Planning Commission Staff Report

MAPLETON
UTAH

Consideration of a request for Preliminary Plat approval for the Whiting Fields Subdivision, an 11-lot subdivision, located at approximately 800 North 400 East in the RA-2 Zone

Development Review Committee Minutes

Attachment "2" - Application information & Plans

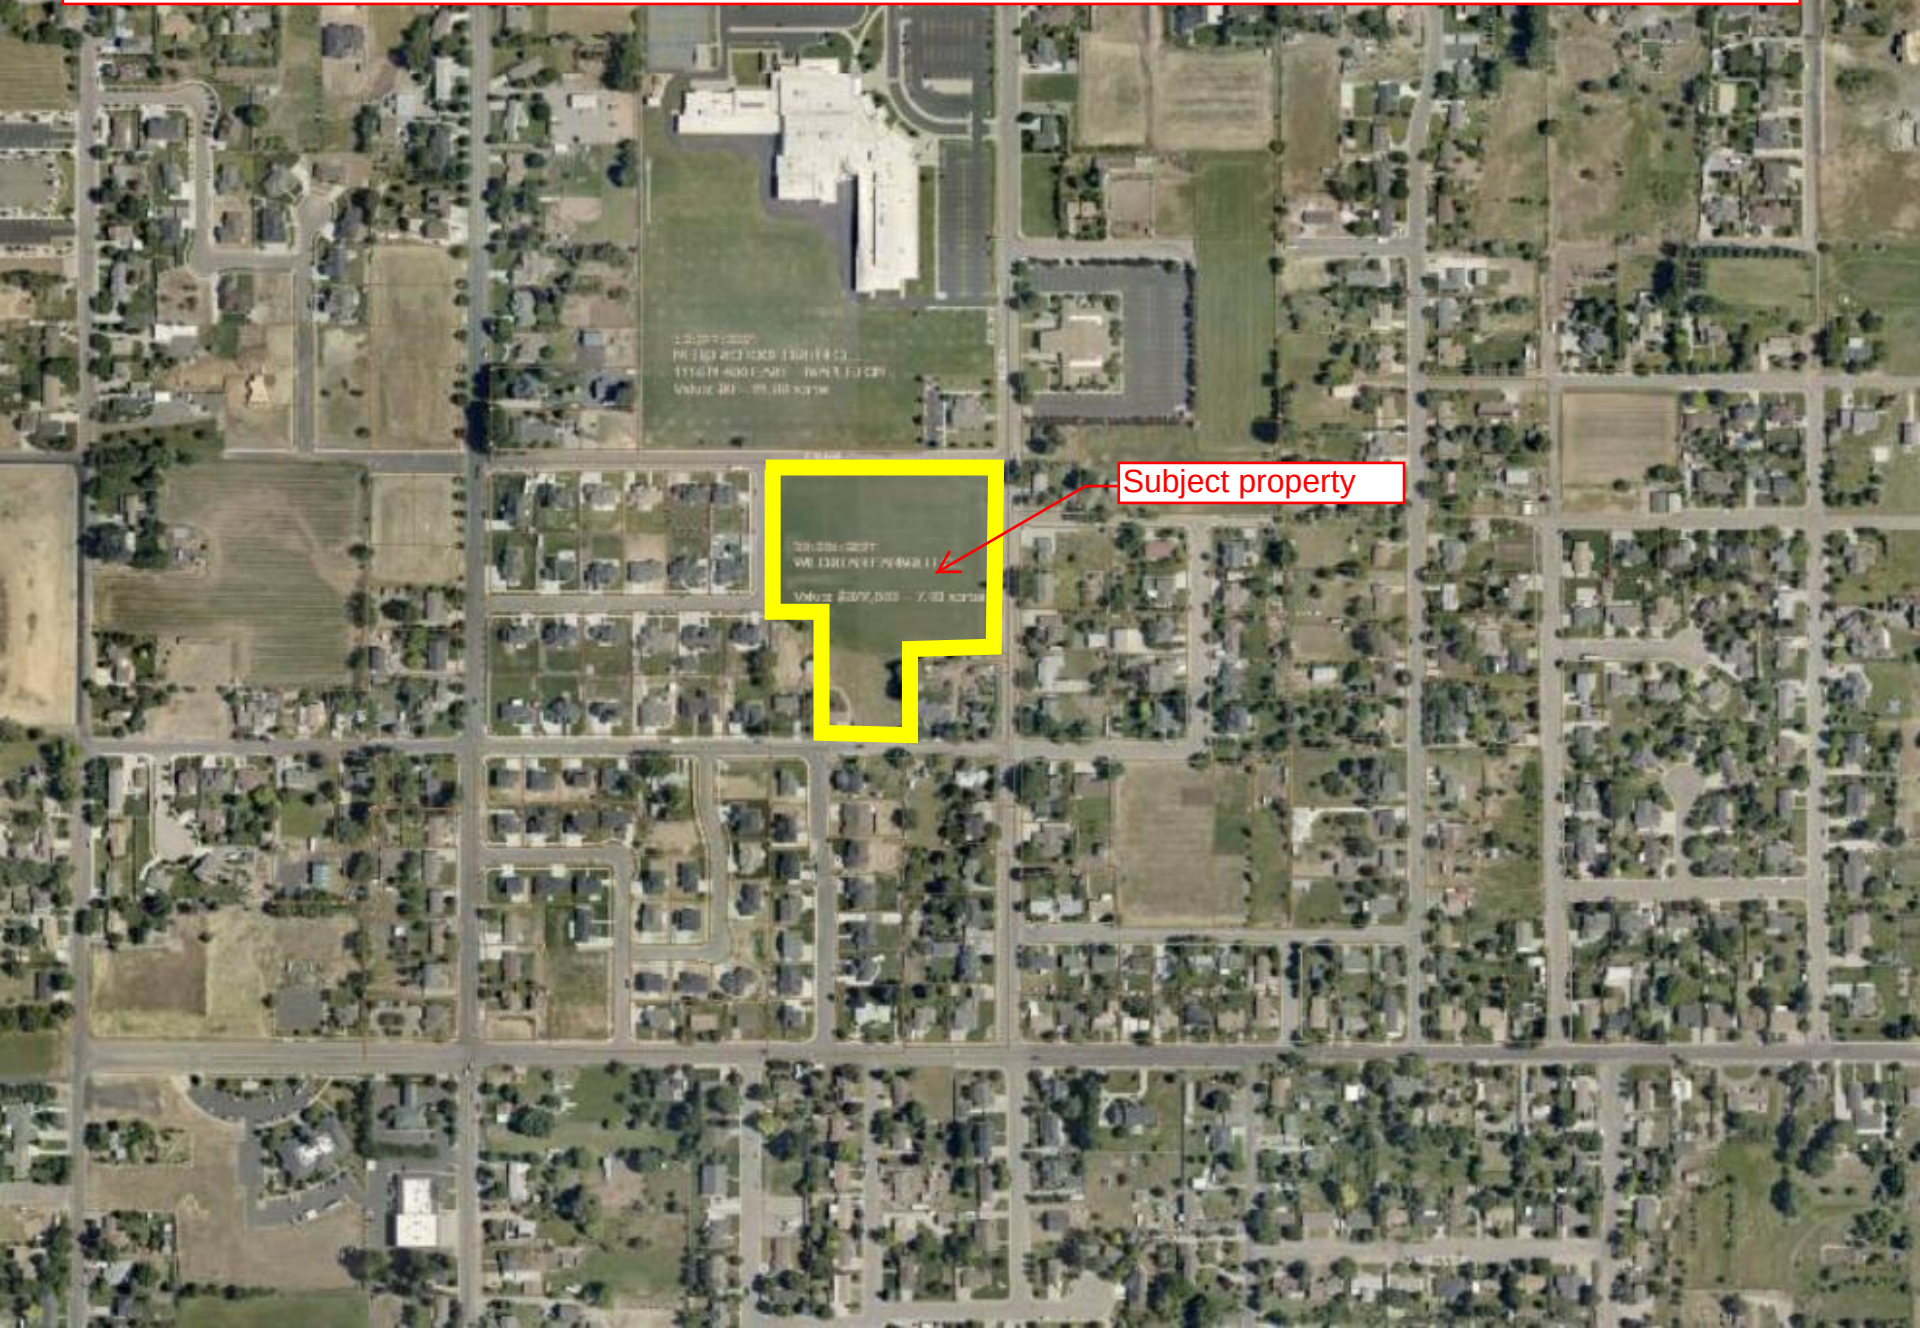
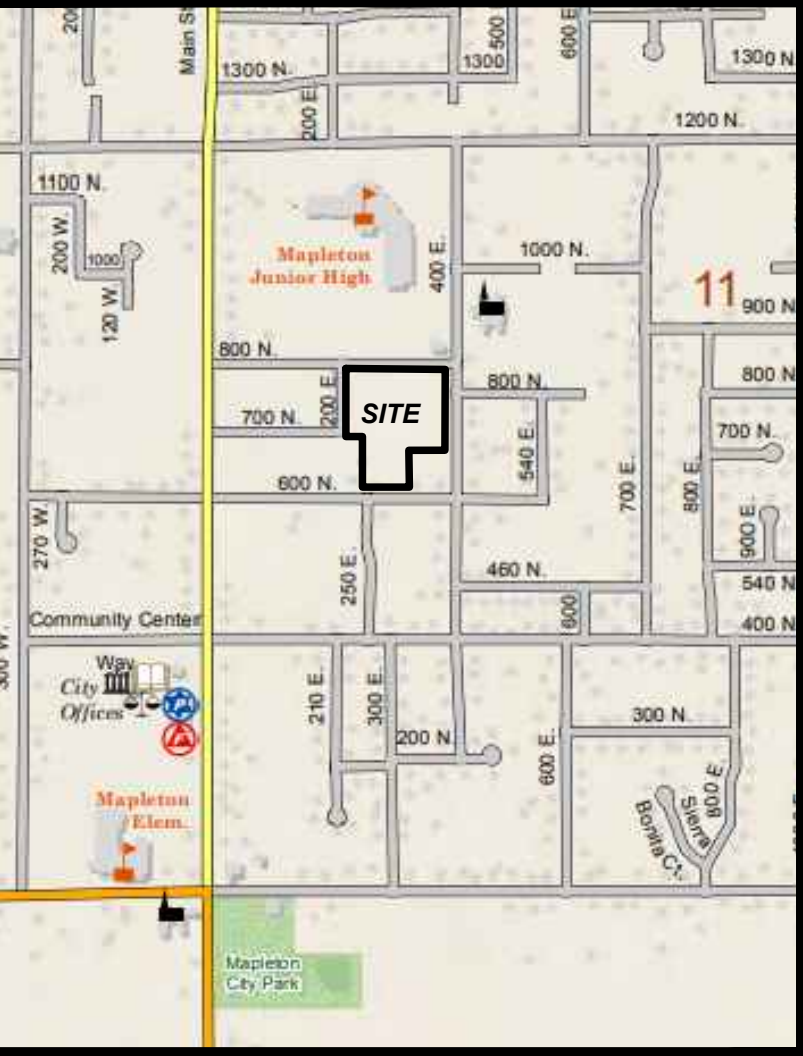
2. 700 North and the cul-de-sac should have a 23' PUE and public access easement on the front of each lot. Please label the 23' easements on 200 East and 400 East "PUE and public access easements."

3. The street dedications should be clearly indicated. Hatched or crossed lines and a legend indicating the dedication will suffice.
